► Trio Motion Technology ◀

Technical Bulletin

Doc No.: TN20-10 Version: 1.0

Subject: Intermittent Power Up, Watchdog operation or Power Failure

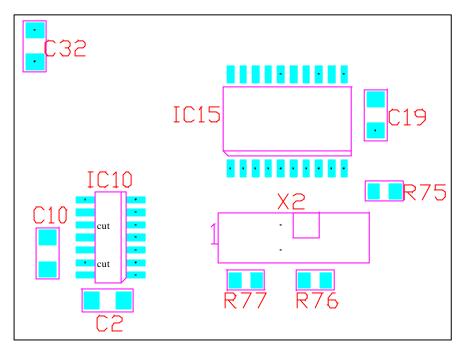
Two pins have to be removed from IC10 as shown on the diagram below. These are pins 10 and 13. To perform this operation it is necessary to remove the plastic bezel from the front of the module, followed by the top cover for the ribbon connector and the right hand side cover. See the manual for more details on assembly of the case. It is suggested that the pins are cut with a fine pair of wire cutters close to the plastic body of the IC and another cut made closer to the PCB to ensure that there is no chance of any remaining part of the pin making contact again.

To avoid potential problems Trio recommend that a small modification is carried out. MC2's can be returned to Trio for modification or carried out by distributors without affecting the warranty. If any MC2's are modified <u>Trio must be informed of the serial number and date the modification was carried out</u>. We will then offer a twelve month warranty from the date of modification provided the modification is carried out within six months of receiving this notification.
